Revision History
Changes compared to Ver2.0 RevB

Texas Instruments 66/3 Bagmane Tech Park CV Raman Nagar Bangalore +91-80-2509-9599		
	Approval	Date	Title CC3100BOOST REL1		
Designer	Prajay M	Date			
Drawn By	Prajay M	Date	Size A2	Project No <Project Number>	Rev 2.0C
Layout	Tessolve	Date	Scale	Date Friday, January 24, 2014	Sheet 1 of 3

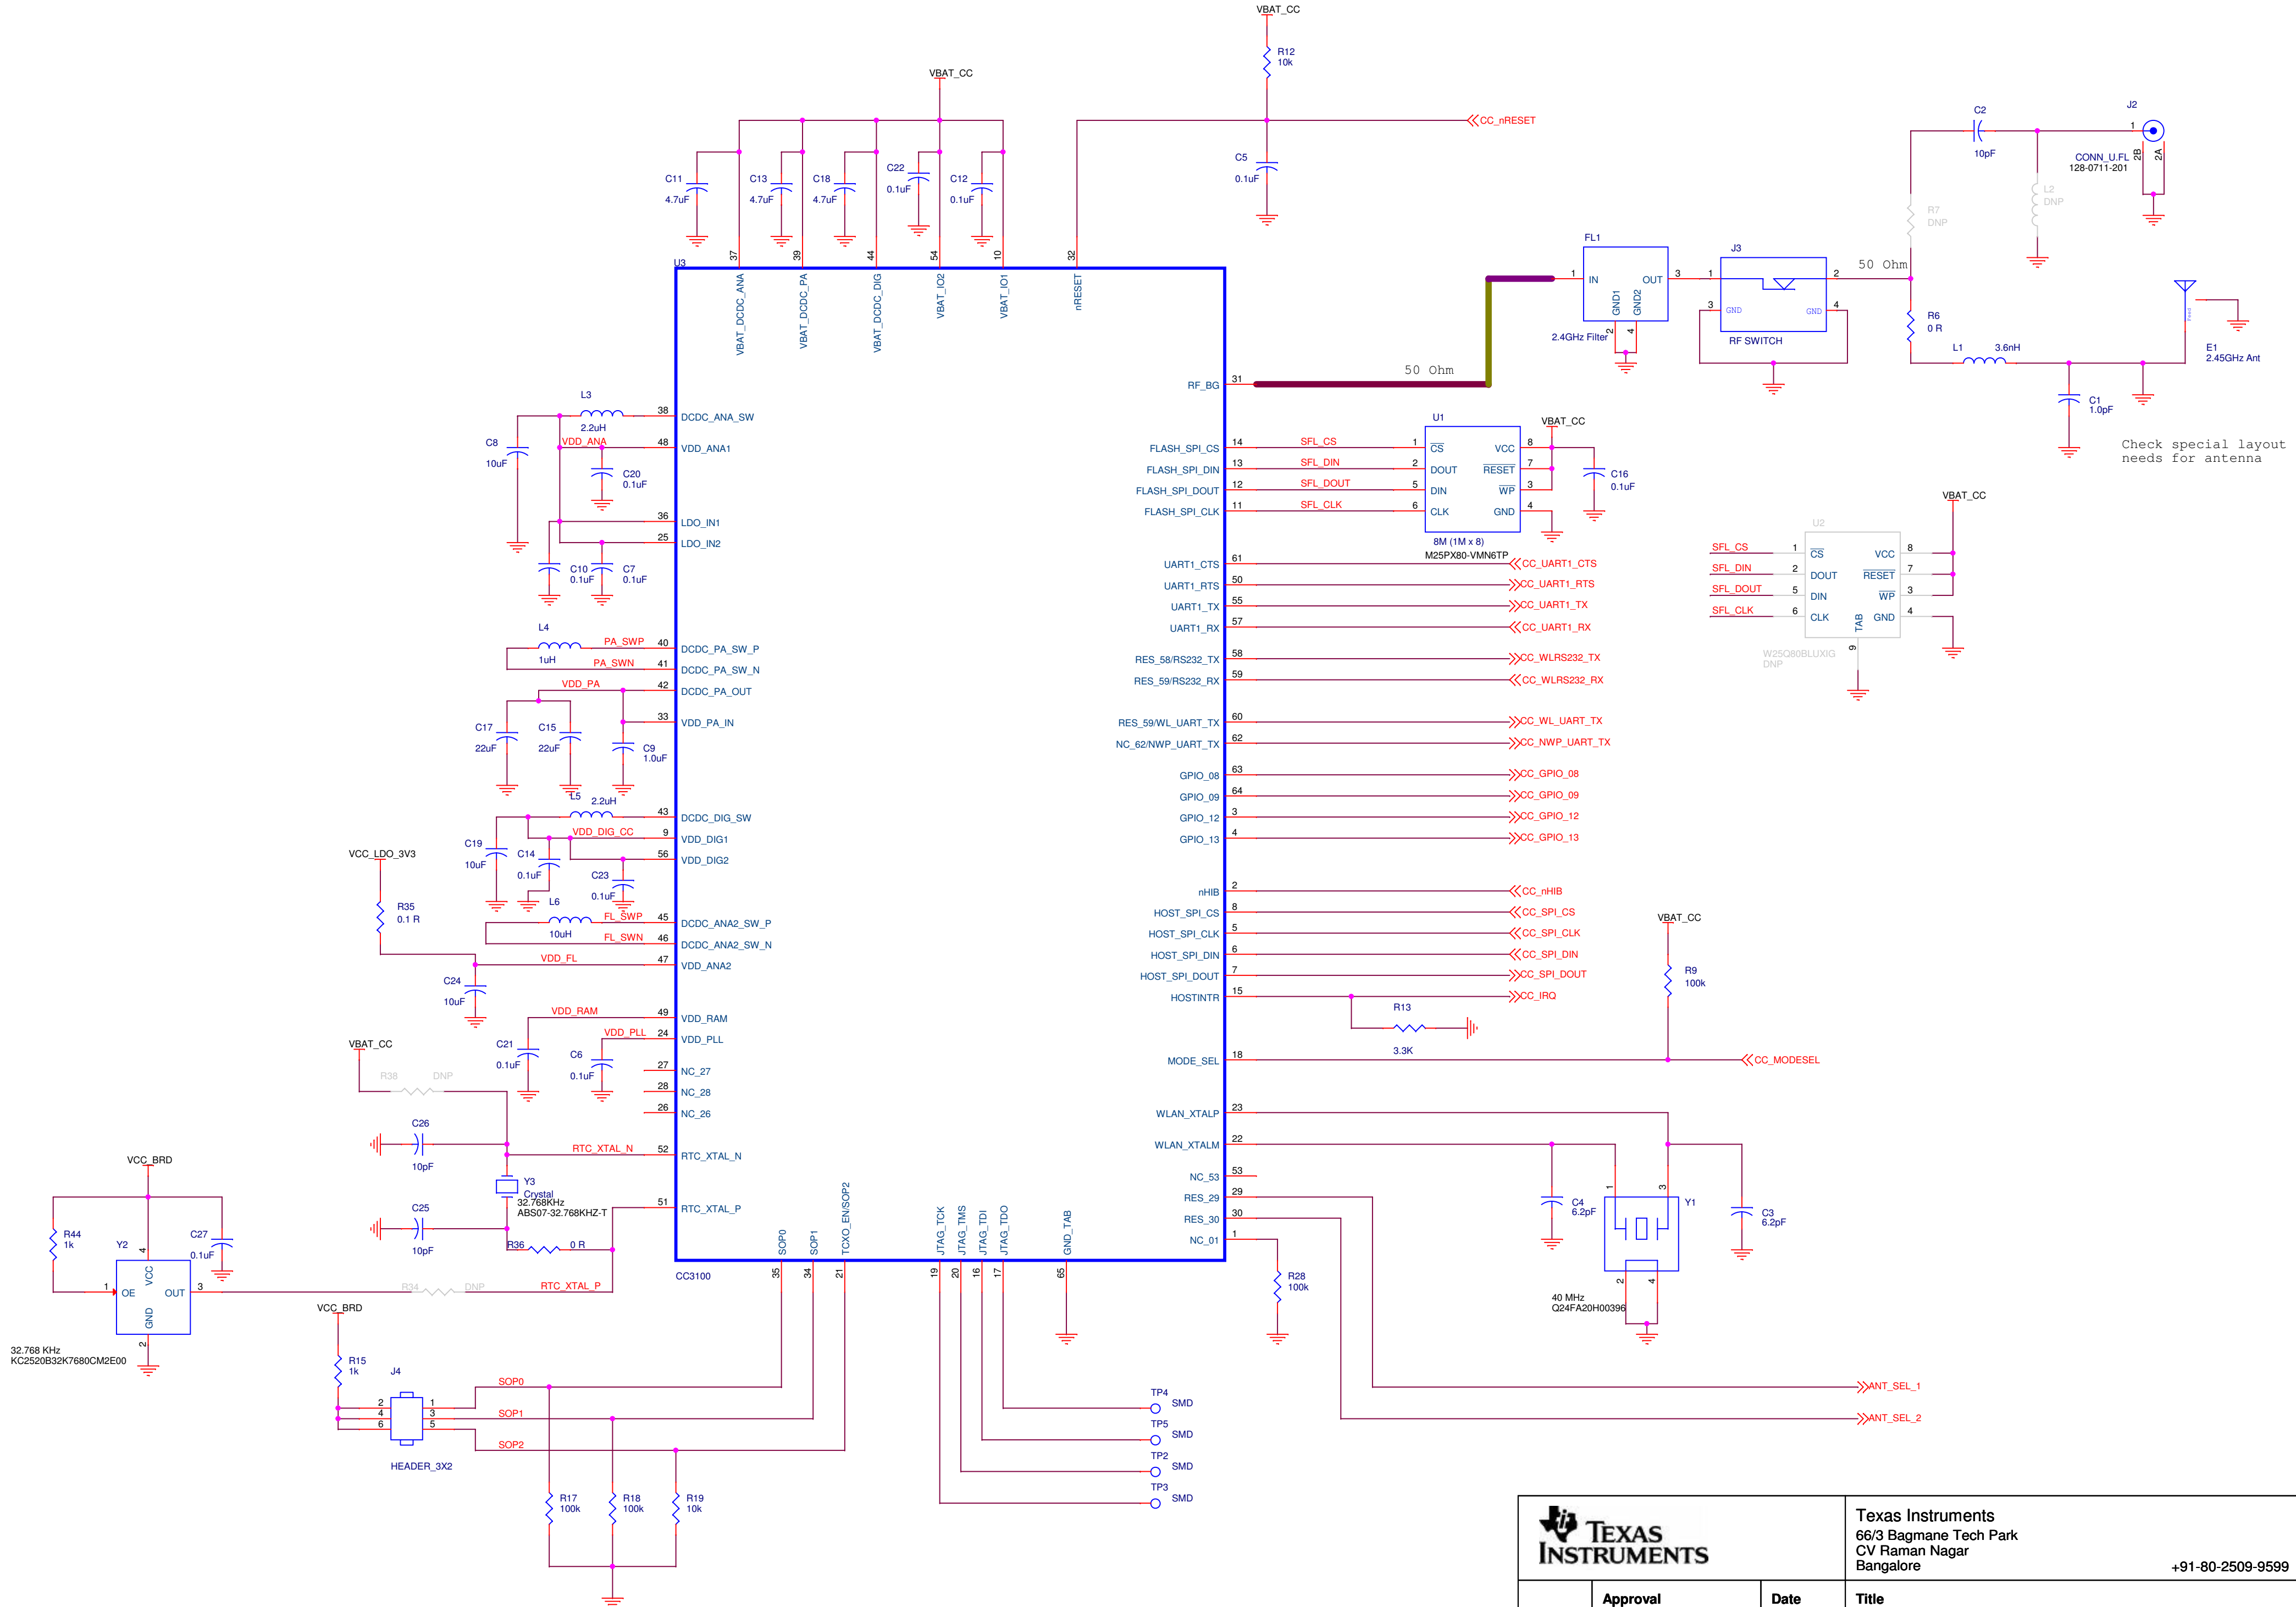
1. Added push button for nHIB
2. Added Murata Connector for RF test
3. Added LED for nRESET
4. Routed the VDD_FLASH to 3.3V
- 4.
